NEWMAR CORP P.O. Box 30, Nappanee, IN. 46550 UNITS: INCHES TITLE BLOCK: 1-5TB	Model: BS/CS CA (SEE INDEX)	Sheet 1 OF 2	Drawn by: R. W.	Checked by: J. S.	Revision: MOVED SWITCH HOLE INWARD 2 3/8" TO MAKE MORE USER FRIENDLY (PCR 170833)	By: R. M. Date: 6/9/16
	Title: PASS CHAIR DASH TRAY	I.D. # 2017\ CA\CAB\LR\ BS1003	Date: 1/5/16	Date: 1/8/16	Revision: New 2017 print; Shortened the CNC'd top to 26 5/8 ILO 31 3/16 due to 2017 MCL 175 to add a foot rest to the passenger chair; Added note to set cabinet 2 1/4" from dashboard	By: R. W. Date: 1/5/16

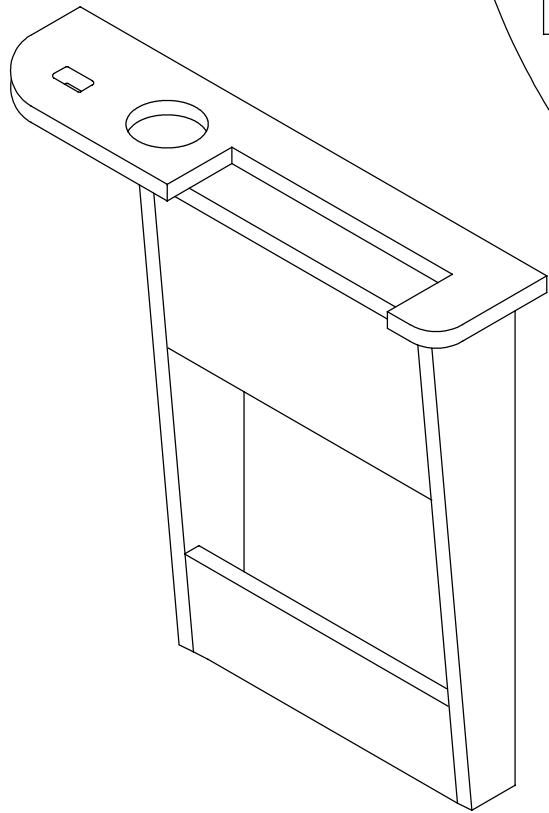
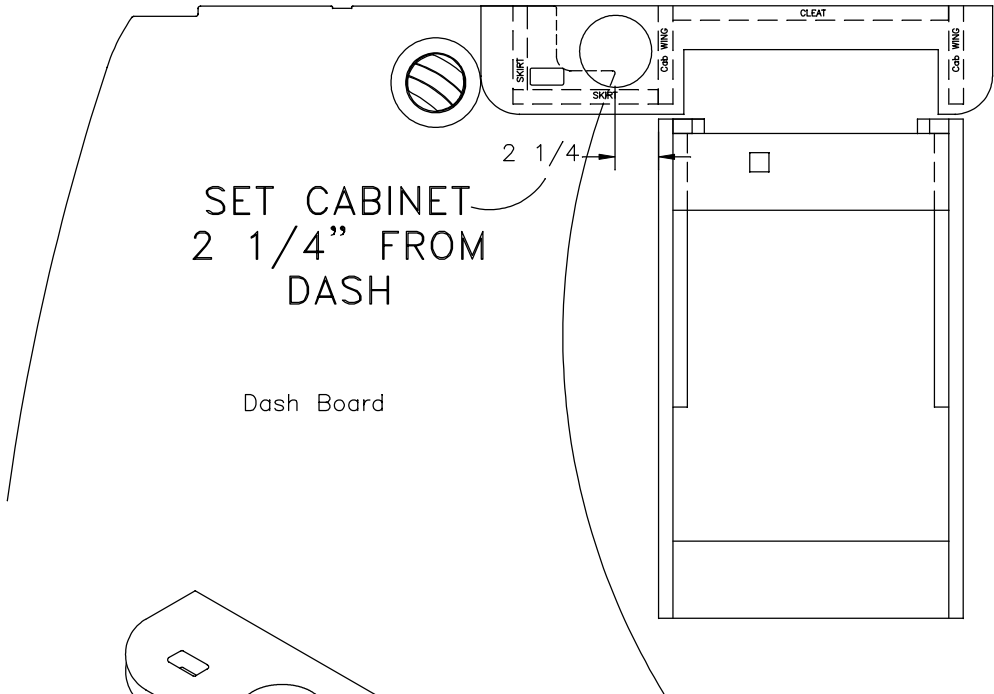
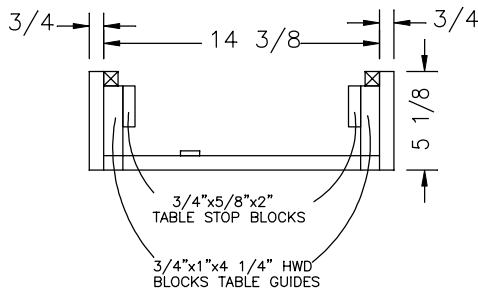
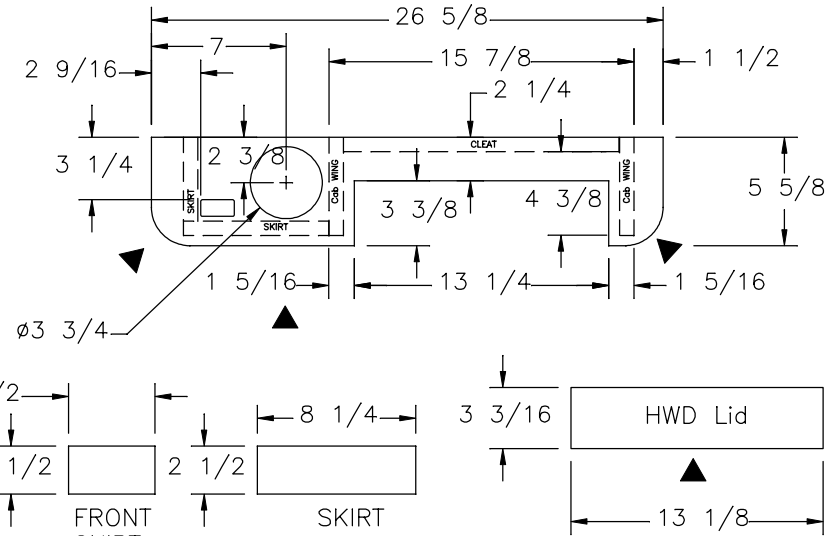
Add brown felt drawer front buttons
on the ends of the table stops to
prevent the table from scratching
